Staff Report

Agenda Date: June 6, 2023
Agenda Item: Variance Request 2320 Meridiana

Project Description: Variances to regulations of the Unified Development Code pertaining to Master UDC Section 3.5.3.12- Storefront Code; Transparency.

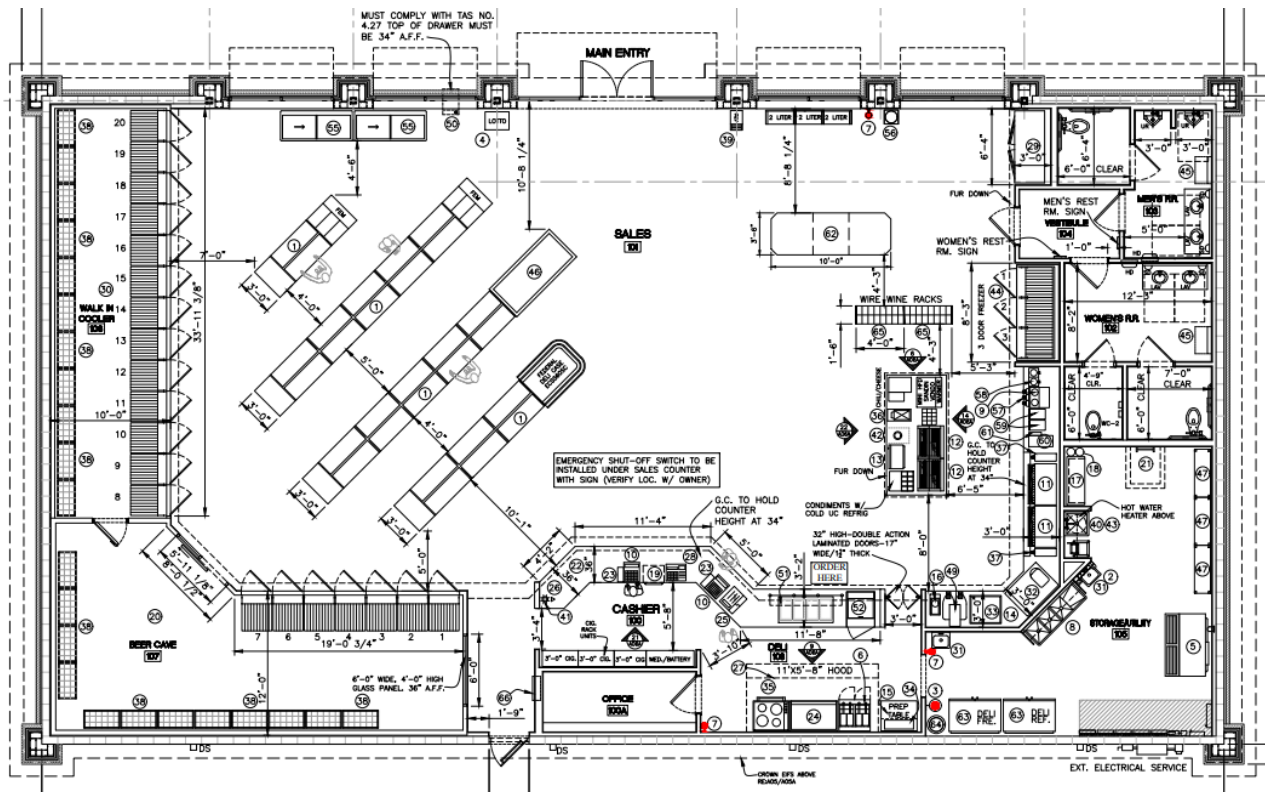
The architectural floor plan does not allow for glazing walls on the East or the Westside of the building, as they enclose the walk in cooler and public restrooms. Please refer to the floor plan attached for reference.

This project is located at the corner of Meridiana and Crystal View Drive, the project complies with the North elevation facing Meridiana Parkway but not the West elevation facing Crystal View Drive.

The purpose of this code is to ensure the security and welfare of the occupants which could be monitored from the street or right of way. Staff recommends that there be some type of transparency to the Westside of the building to meet the intent of the Unified Development Code.
